Access Report

**Tumbi Umbi Retirement  
Living Project**

14 Mingara Drive  
TUMBI UMBI NSW 2261

For: Mingara Leisure Group Pty Ltd  
Ref: PAA\_23342

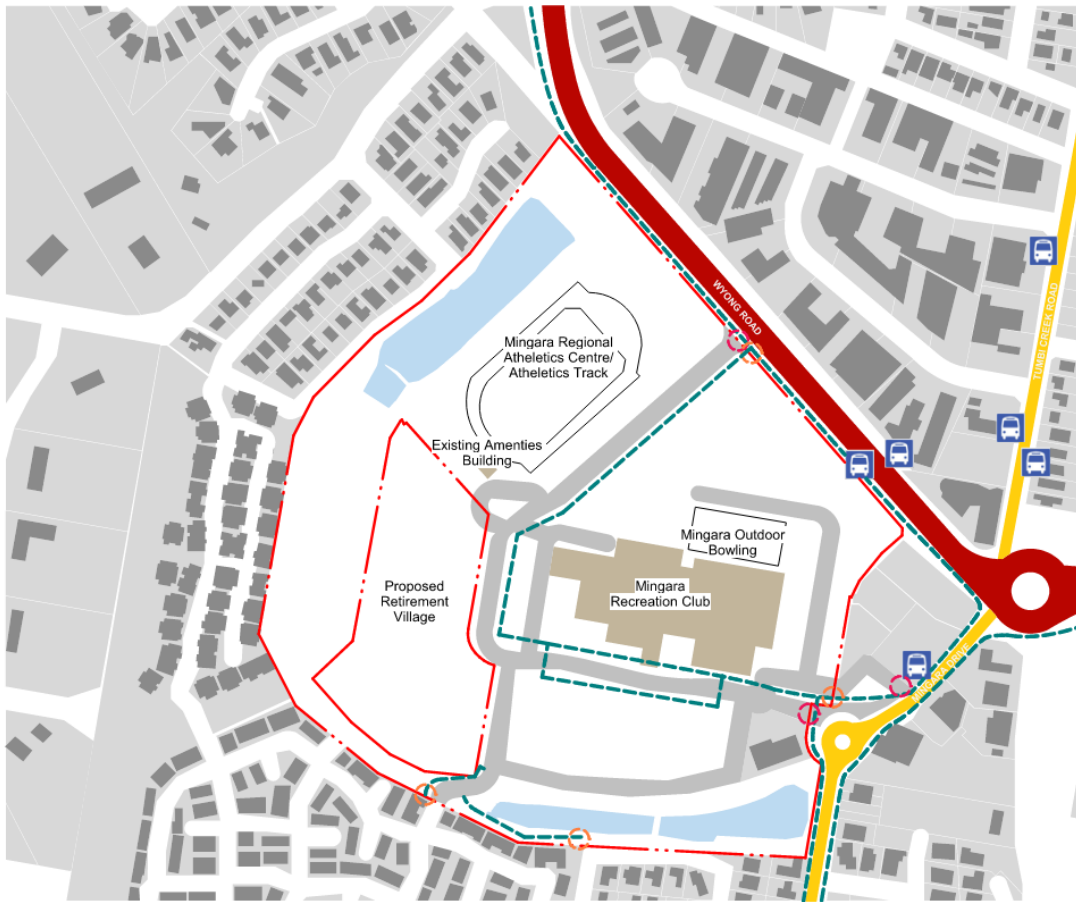
The site lies within 400m of two (2) bus stops providing different bus services to Wyong or Bateau Bay.

- Bus stop 1 is located on Wyong Road for services to Wyong
- Bus stop 2 is located on Mingara Drive for services to and from Bateau Bay.

A separate medical centre is provided on the corner of Mingara Drive and Hansens Road. This is located near the bus stop and the yellow roundabout in the image below.

The existing pedestrian pathways to and from each bus stop are positioned on one side of both roadways. Additional pedestrian crossings can be provided at the time of detailed design.
